# Access Compliance Report

## Public Rights-of-Way

Intersection ID: 10019902	Main Street: ARCO_CORPORATE_DR	Cross Street: N/A	Location: NW
ADA ID: 440BF3930B41	Ramp Type: PerpDiag	Initial Pass/Fail: Fail	Overall Compliance: No
Severity Score: 25			
Codes/Mitigation Info/Possible Solution		Field Measurements/Component Compliance

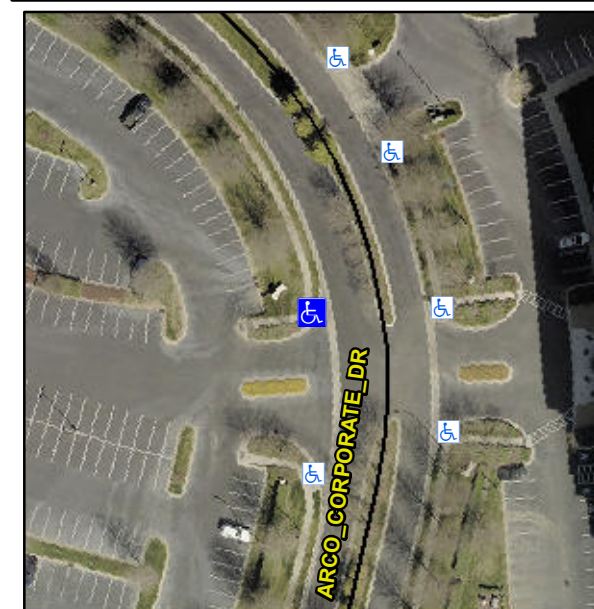
**Not Found, R304.2.2, R304.5.3**

Compliance	Description	Data	Compliance	Description	Data
N/A	Ramp Length (in)	49.0	No	Ramp Slope (%)	8.7
Yes	Ramp Width (in)	48.0	No	Ramp XSlope (%)	5.1
N/A	Flare Type LT	N/A	N/A	Flare Type RT	N/A
N/A	Flare Slope LT (%)	N/A	N/A	Flare Slope RT (%)	N/A
N/A	Flare Traversable LT?	N/A	N/A	Flare Traversable RT?	N/A
N/A	Landing Length (in)	N/A	N/A	DWS Provided?	N/A
N/A	Landing Width (in)	N/A	N/A	DWS Contrast?	N/A
N/A	Landing Slope (%)	N/A	N/A	DWS Length (in)	N/A
N/A	Landing X Slope (%)	N/A	N/A	DWS Full Width?	N/A
N/A	Landing Curb? (Y/N)	N/A	N/A	DWS Offset (in)	N/A
N/A	Shared Landing?	N/A			
N/A	Gutter Ponding?	N/A	N/A	Gutter Slope (%)	N/A
N/A	Gutter Lip Ht (in)	N/A	N/A	Gutter X Slope (%)	N/A
N/A	Painted X Walk1?	No	N/A	Painted X Walk2?	No
	X Walk 1 Direction	To SW		X Walk 2 Direction	To E
N/A	X Walk 1 Width (in)	N/A	N/A	X Walk 2 Width (in)	N/A
	X Walk 1 Slope (%)	5.6		X Walk 2 Slope (%)	2.8
	X Walk 1 X Slope (%)	0.9		X Walk 2 X Slope (%)	4.7

**Remove & Replace Curb Ramp With Two New Directional Ramps or Equivalent.**
